Item Name: Crosstube Turning Detail

DART AEROSPACE LTD	Work Order:	107541
Description: Crosstube Assembly (412 High Aft)	Part Number:	D412-664-243
Inspection Dwg: D412-664-243 Rev: E		Page 1 of 2

DRAWING NO. D412-664-243	TITLE CROSSTUBE ASS'Y (412 HI AFT)	REV. E	DART AEROSPACE LTD ENGINEERING ORDER		D.E.O. NO. D412-664-243-E-2	SHEET NO. SHEET 1 OF 1	SCALE NTS
DRAWN <i>MP</i>	CHECKED <i>ASS</i>	MFG. APPR. <i>EE</i>	APPROVED <i>MP</i>		DE APPR. <i>#</i>		
DATE 11.09.07	DATE 11.09.19	DATE 11.09.19	DATE 11.09.19		DATE 11.09.19

DRAWING NO. D412-664-243	TITLE CROSSTUBE ASSEMBLY (412 HI AFT)	REV. E	DART AEROSPACE LTD ENGINEERING ORDER		D.E.O. NO. D412-664-243-E-4	SHEET NO. SHEET 1 OF 3	SCALE NTS
DRAWN 92	CHECKED A	MFG. APPR. A	APPROVED MP		DE APPR. MP		
DATE 12.08.21	DATE 12.08.30	DATE 12.08.30	DATE 12/8/30		DATE 12.08.30

**D412-664-243
ASSEMBLY DETAIL**

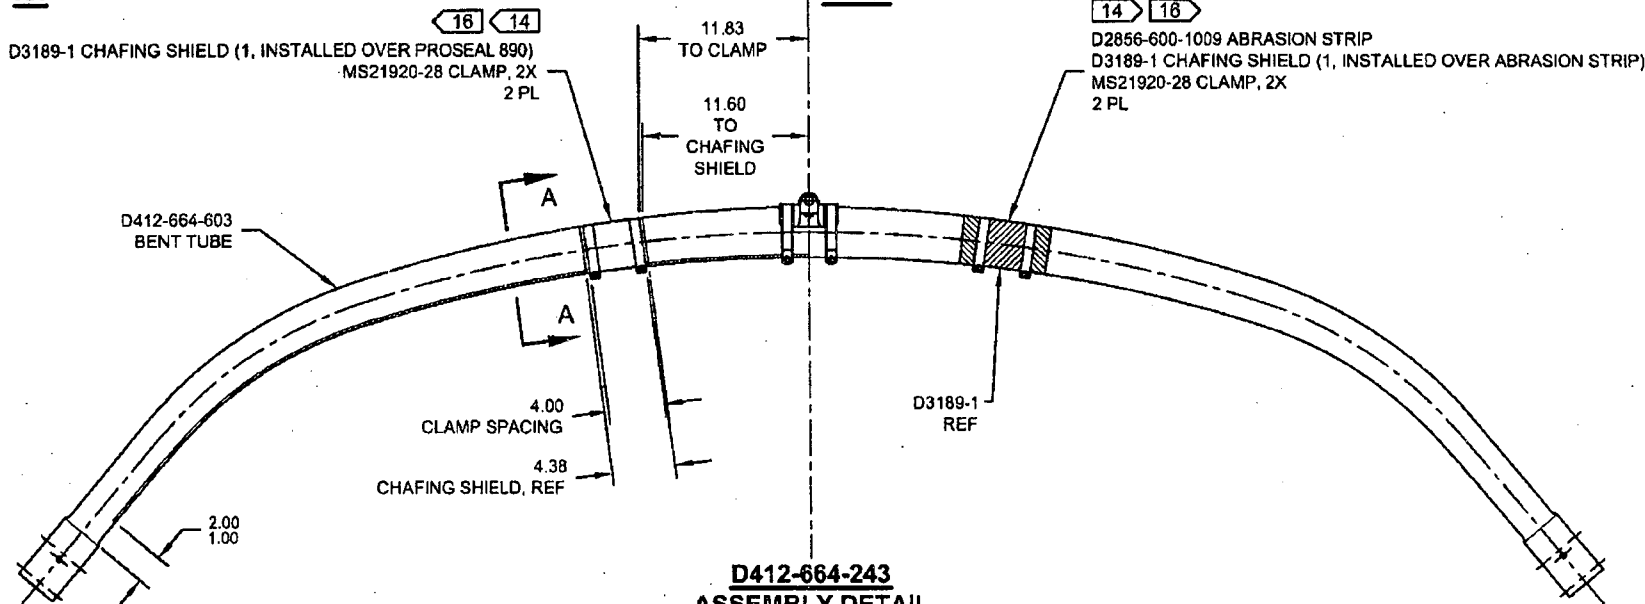
REMOVED ABRASION STRIP IN FAVOR OF A THIN LAYER OF PROSEAL 890. UPDATE INSTALLATION OF CHAFING SHIELDS AND REDUCE TORQUE TO 40-50 IN-LBS. THIS ENGINEERING ORDER SUPERCEDES DEO D412-664-243-E-1.

IS:

D3189-1 CHAFING SHIELD (1, INSTALLED OVER PROSEAL 890)
MS21920-28 CLAMP, 2X
2 PL

WAS:

D2856-600-1009 ABRASION STRIP
D3189-1 CHAFING SHIELD (1, INSTALLED OVER ABRASION STRIP)
MS21920-28 CLAMP, 2X
2 PL

MASK AREA PRIOR TO PAINTING AND
APPLY CLEAR COAT AFTER PAINTING

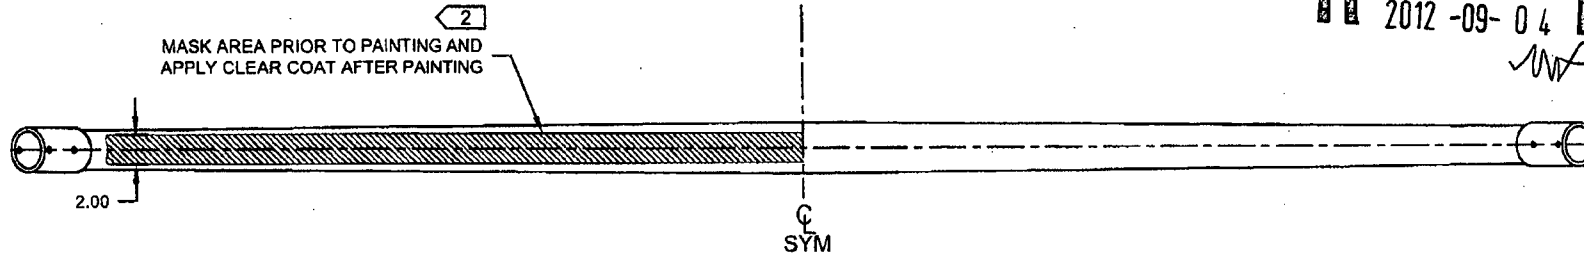
- 2) FINISH: CHEMICAL CONVERSION COAT PER DART QSI 005 4.1
PRIME INSIDE AND OUTSIDE PER DART QSI 005 4.2
MASK UNDERSIDE OF CROSSTUBE AS SHOWN (HATCHED AREA)
PAINT OUTSIDE PER DART QSI 005 4.2
AFTER PAINTING, APPLY CLEAR COAT ON HATCHED AREA
- 14) APPLY A THIN COAT OF PROSEAL 890 ON INSIDE CONCAVE SURFACE OF D3189-1 CHAFING SHIELD AND LET CURE PER MANUFACTURER'S INSTRUCTIONS. INSTALL PROSEALED D3189-1 CHAFING SHIELD ONTO CROSSTUBE BY APPLYING A THIN COAT OF PROSEAL 890 ONTO CROSSTUBE. BE SURE TO ELIMINATE ANY AIR GAPS.
- 16) TORQUE CLAMPS ON D2896-1 SUPPORT 80 TO 100 IN-LB. **TORQUE CLAMPS ON D3189-1 CHAFING SHIELD 40 TO 50 IN-LB.**
ENSURE AT LEAST 1.5 THREADS SHOWING IN SAFETY AND THAT NUT HAS NOT BOTTOMED-OUT AFTER TORQUING.
